Access Compliance Report

Public Rights-of-Way

(Curb Ramps)

Intersection ID: 22230	Main Street: N_SARDIS_VIEW_LN	Cross Street: SARDIS_RD	Location: N
ADA ID: D7A845248C53	Ramp Type: PerpDiag	Initial Pass/Fail: Fail	Overall Compliance: No
Severity Score: 8.75			
Codes/Mitigation Info/Possible Solution		Field Measurements/Component Compliance

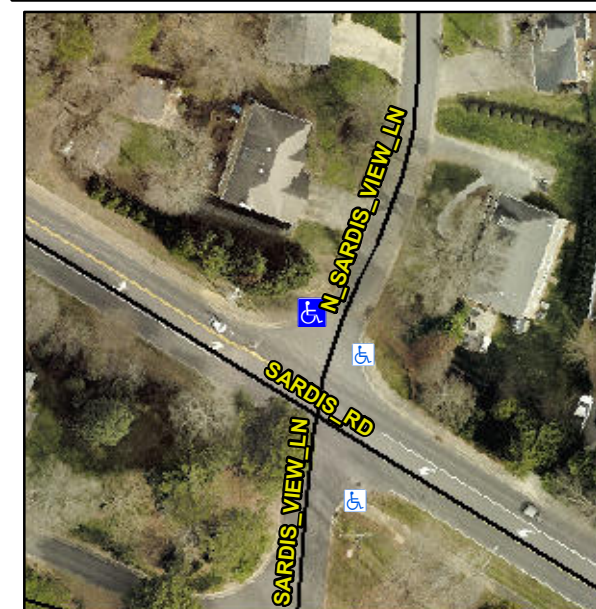
R304.5.1

Compliance	Description	Data	Compliance	Description	Data
N/A	Ramp Length (in)	60.0	Yes	Ramp Slope (%)	8.3
No	Ramp Width (in)	42.0	Yes	Ramp XSlope (%)	2.0
N/A	Flare Type LT	N/A	N/A	Flare Type RT	N/A
N/A	Flare Slope LT (%)	N/A	N/A	Flare Slope RT (%)	N/A
N/A	Flare Traversable LT?	N/A	N/A	Flare Traversable RT?	N/A
N/A	Landing Length (in)	N/A	N/A	DWS Provided?	N/A
N/A	Landing Width (in)	N/A	N/A	DWS Contrast?	N/A
N/A	Landing Slope (%)	N/A	N/A	DWS Length (in)	N/A
N/A	Landing X Slope (%)	N/A	N/A	DWS Full Width?	N/A
N/A	Landing Curb? (Y/N)	N/A	N/A	DWS Offset (in)	N/A
N/A	Shared Landing?	N/A			
N/A	Gutter Ponding?	N/A	N/A	Gutter Slope (%)	N/A
N/A	Gutter Lip Ht (in)	N/A	N/A	Gutter X Slope (%)	N/A
N/A	Painted X Walk1?	No	N/A	Painted X Walk2?	No
	X Walk 1 Direction	To SW		X Walk 2 Direction	To SE
N/A	X Walk 1 Width (in)	N/A	N/A	X Walk 2 Width (in)	N/A
	X Walk 1 Slope (%)	0.9		X Walk 2 Slope (%)	4.4
	X Walk 1 X Slope (%)	5.6		X Walk 2 X Slope (%)	2.8

Remove & Replace Curb Ramp With Two New Directional Ramps or Equivalent.
